Three Mile Island Nuclear Station - Unit 1
Docket No. 50-289

PRELIMINARY COMMENTS AND QUESTIONS
Review of FSAR, Volume 2, Appendix 5A
"Summary of Aircraft Impact Design"

by
James F. Proctor
Air/Ground Explosions Division
U. S. Naval Ordnance Laboratory

REACTION LOAD CURVES FOR B720
HEAD-ON CRASH AT 200-KNOT SPEED

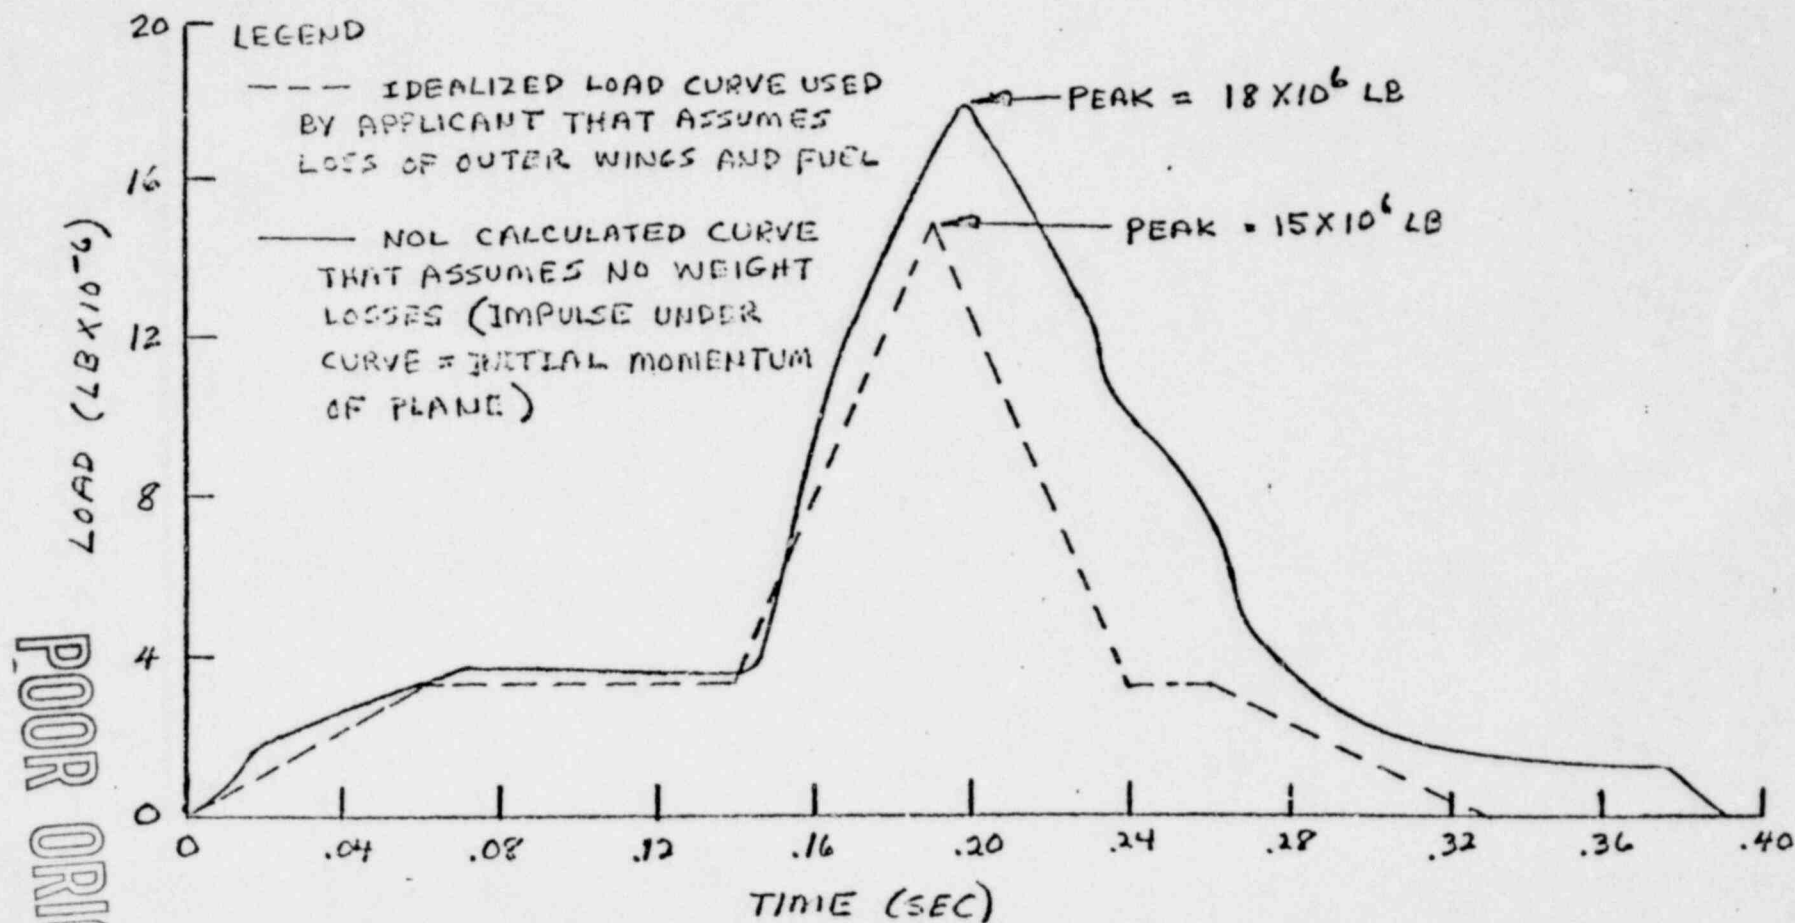
The basic approach used in calculating the impact loads for Case D (realistic crash of 200,000-lb craft at 200 knots) appears to be appropriate for this problem. However, certain assumptions were made regarding loss of engines, outer portions of wings, and fuel that are open to question. In Figure 1

it is shown that if the aircraft remains together (no loss of weight) the peak load is 18×10^6 lb. Also the area under the solid load time curve (impulse) is equal to the initial momentum of the 200,000-lb aircraft with a 200-knot velocity. The dashed curve used by the applicant (from Fig. 5A-1 and Table 5A-1 of FSAR) shows a peak load of 15×10^6 lb but loss of engines, fuel, and wing structure were assumed. (There are some internal inconsistencies between the applicant's curves Fig. 5A-1, 5A-2 and Table 5A-6 which shows a peak of 16.2×10^6 lb.) It is not clear exactly how this lost weight was handled, i.e., no criteria were presented to show when these pieces would break away from the main aircraft. Also it doesn't appear that these now free pieces of the aircraft were treated as additional colliding masses on the subject reactor structure at some location removed from the main fuselage loading. Ordinarily these types of comments could be classified as "nit picking", but they could represent 10 or 20% type deviations. When one considers that the applicant has stretched the concrete capability of the reactor dome to an absolute maximum to show its resistance to the 15×10^6 -lb peak load, and additional 10 to 20% load may be the proverbial straw breaking the camel's back. My conclusion on reactor dome response is that the applicant has shown that the dome has a fair chance of surviving the unlikely head-on crash of a 200,000-lb aircraft traveling at 200 knots, but I cannot at this time fully endorse his final statement in Section 3.1.1.3 that "...the conclusion can be safely drawn that the dome will not collapse...".

1. Define the criteria used to determine when the out-board engines, outer portion of wings, and fuel break away from the aircraft during impact.

2. Discuss the effect on load and building response of the combined impact of the remaining aircraft and these free separated missiles.

3. The peak impact load is given in Figure 5A-2 and other places in Appendix 5A as 15×10^6 lb, but the calculations in Table 5A-6 show 16.2×10^6 . Clarify the correct peak load and include any changes that might be introduced by Items 1 and 2 above.

DYNAMIC LOAD FACTOR (DLF) VS. PERIOD OF ONE DEGREE FREEDOM SYSTEM

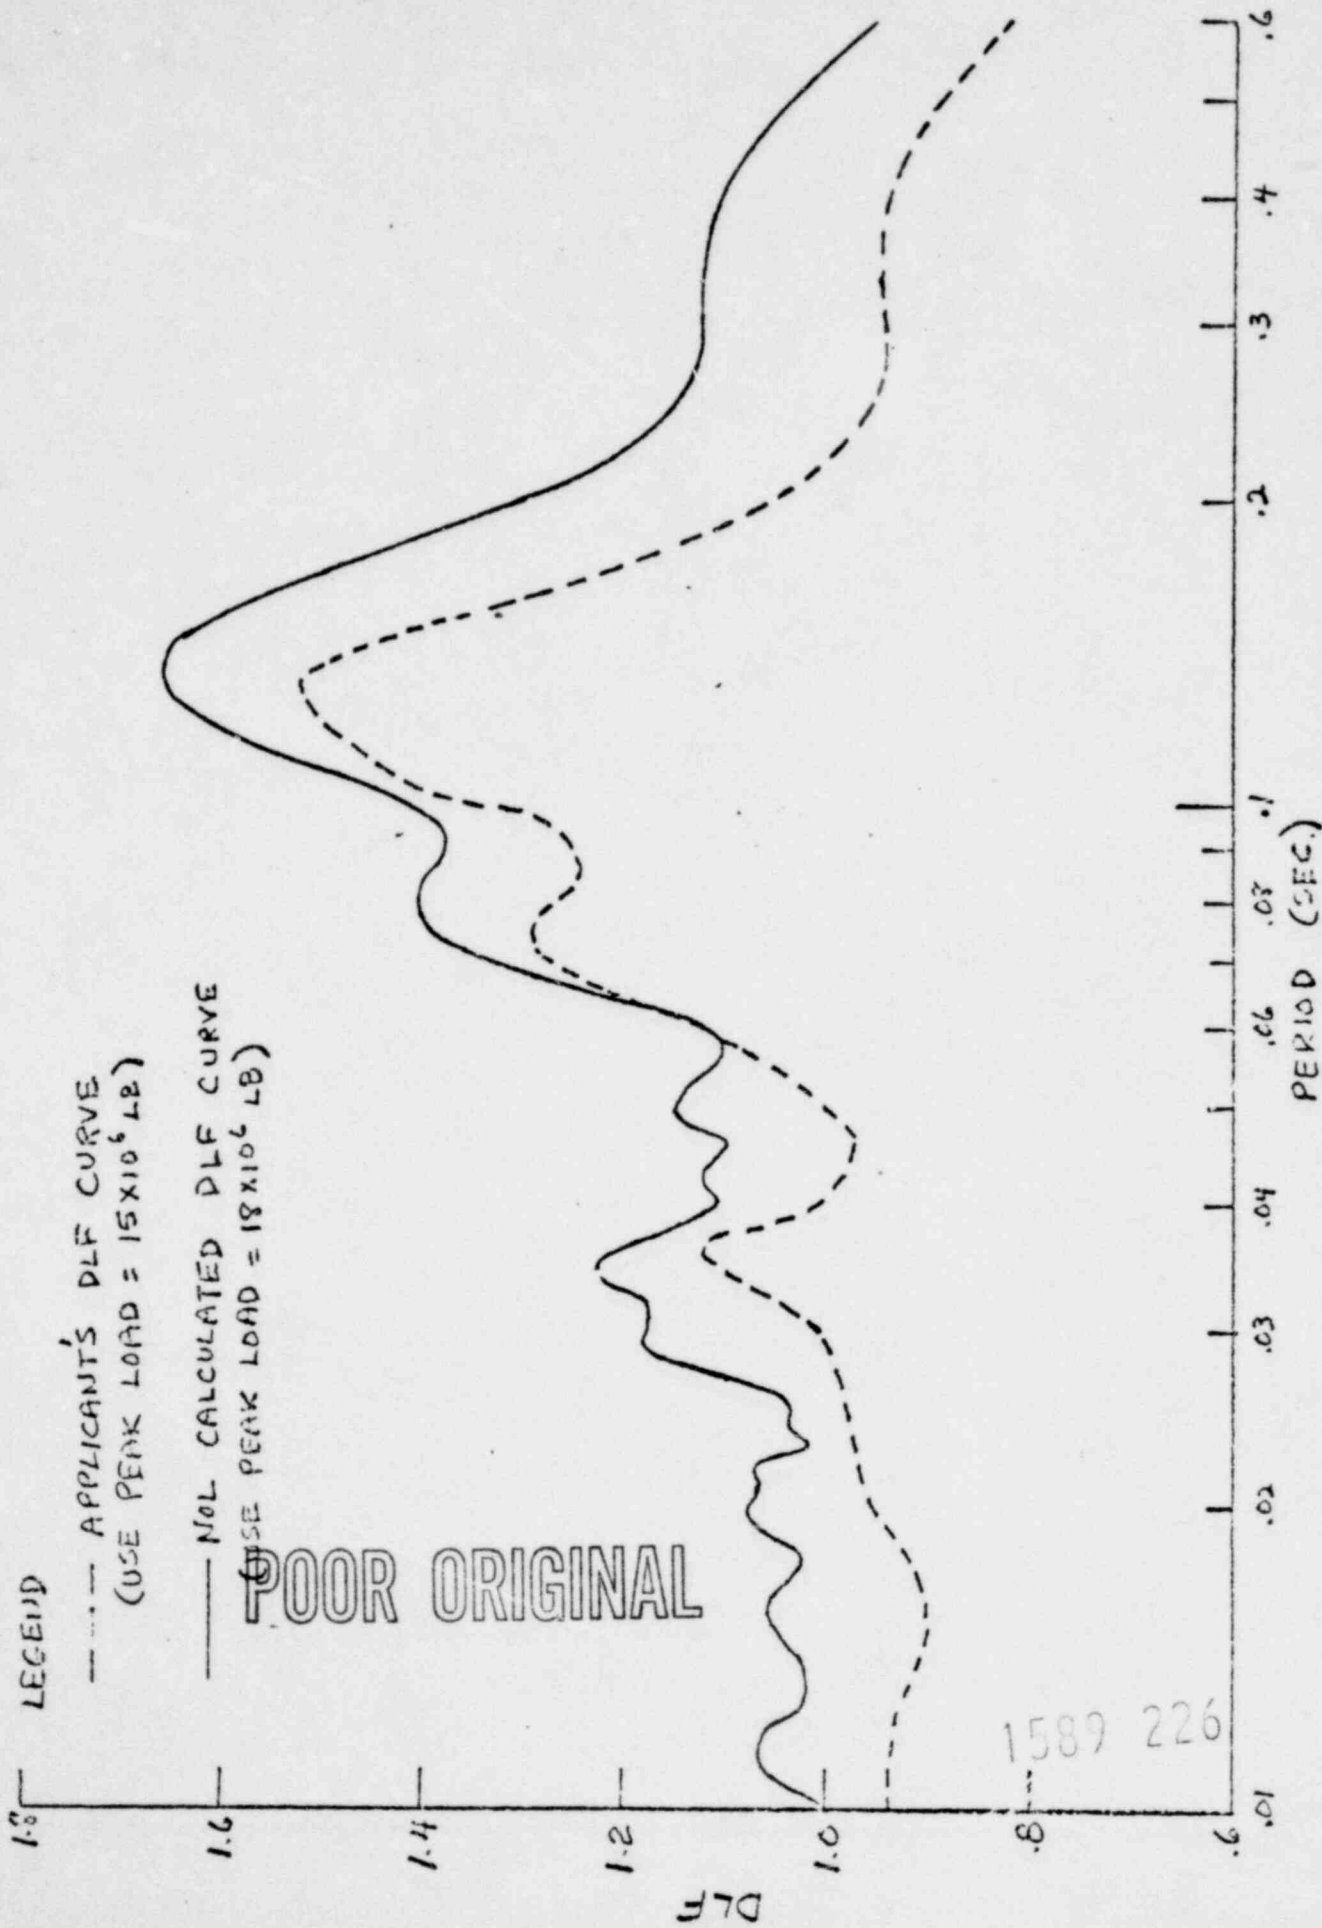
This entire question of peak load magnitude influences the structural response calculations of other concrete structures which are treated as flat plates via the use of dynamic load factors (DLF) discussed in Section 2 of Appendix 5A. Depending on the loading-time curve used, we see in Figure 2 that differences of the order of 10% can occur in the calculation of DLF. Coupled with variation of peak loads, this might indicate response or stress differences of 30 to 40%. Aside from the magnitude of the load itself, questions can be raised about the method of calculating the fundamental frequency discussed in Section 3.2.1 of Appendix 5A. The frequency of a linear elastic flexural system such as that assumed by the applicant varies directly with the square root of the modulus of elasticity E . Normally E for concrete is taken to be about 1000 times its compressive strength. Actually this is an approximation of the initial slope of the non-linear stress-strain curve for concrete. Thus frequency based on such an E would hold only for relatively low stress levels. As concrete is loaded nearer its compressive capability, the slope of the stress-strain curve is substantially reduced; therefore, it would not be unexpected to find that the fundamental frequency of a concrete slab or wall would vary with the magnitude of the load. This together with the unknowns of treating a wall panel of a complex structure as a single degree of freedom system could lead to significant shifts in response frequency.

If this is true, it would seem more prudent and certainly more conservative to assume the maximum DLF in designing exterior wall panels of structures to withstand aircraft impact. If the wall panels are designed stress-wise as marginally as the dome for aircraft impact, then I would again conclude that whereas the applicant has demonstrated that the structures can withstand large impact loads, he has not positively shown assured safety against the head-on crash of a 200,000-lb aircraft traveling at 200 knots.

5. Justify the use of a single-degree-of-freedom system to analyze the response of a multi-degree system such as the auxiliary building. To what degree, if any, does this assumption affect natural frequency and the choice of DLF.

6. What value of Young's modulus was used in calculating the natural frequency of a concrete panel. Since frequency varies with Young's modulus and concrete is a non-elastic material, discuss the possibility of a shift in frequency for a concrete panel under normal load and impact loading and the effect this might have on DLF. Also discuss the effects of variation in the assumed edge conditions for the panels on frequency and DLF.
